32-BIT MICROCONTROLLER STARTERKIT  
**SK-FM3-100PMC**

**FUNCTIONAL LIMITATION**

**CUSTOMER INFORMATION**

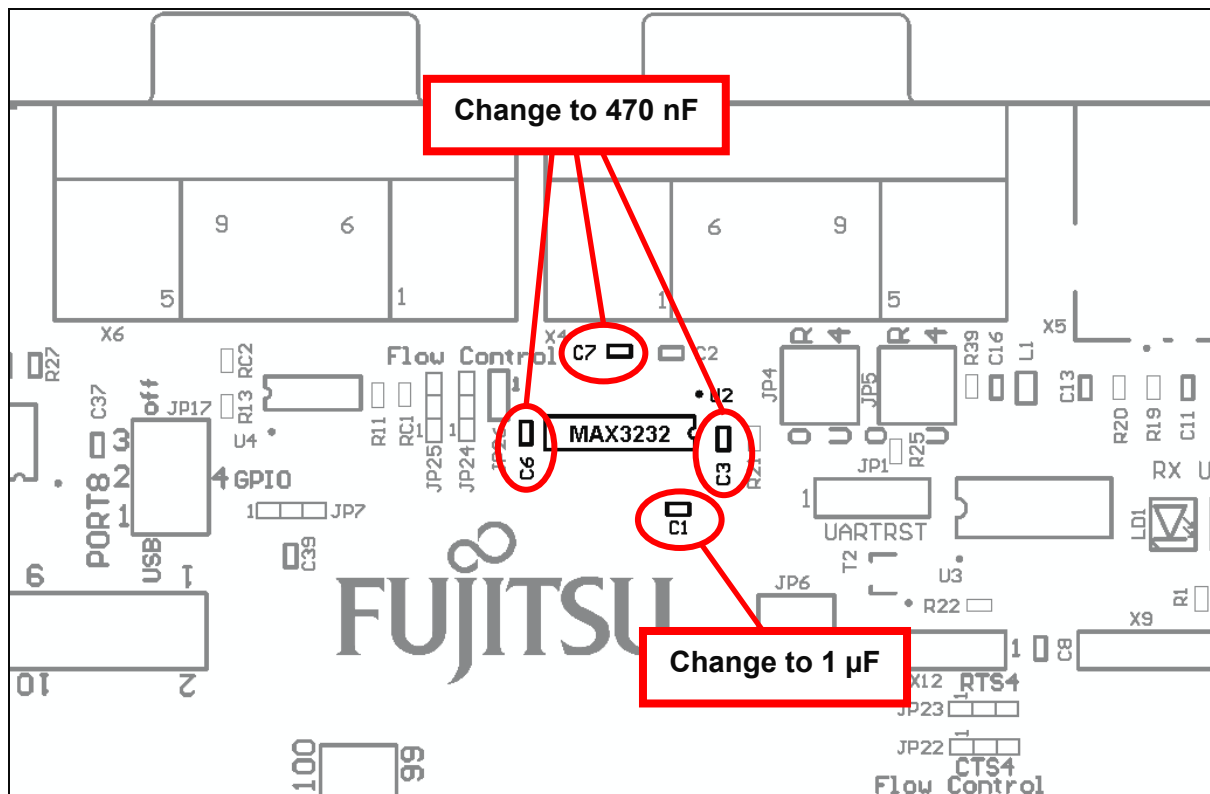
The external capacitors for the MAX3232 are too small according to MAXIM™'s specification for usage between VCC = 3.3 Volts and VCC = 5 Volts, resulting in a VCC noise ripple. This ripple influences the AVCC and AVRH analog supply and reference voltage inputs, which leads to inaccurate ADC conversion results.

For ADC usage the following capacitors have to be replaced with new values:

The capacitors are located on the board shown in the illustration below:

Capacitor reference	Old value	New corrected value
C1	100 nF	1 $\mu$ F
C3	100 nF	470 nF
C6	100 nF	470 nF
C7	100 nF	470 nF
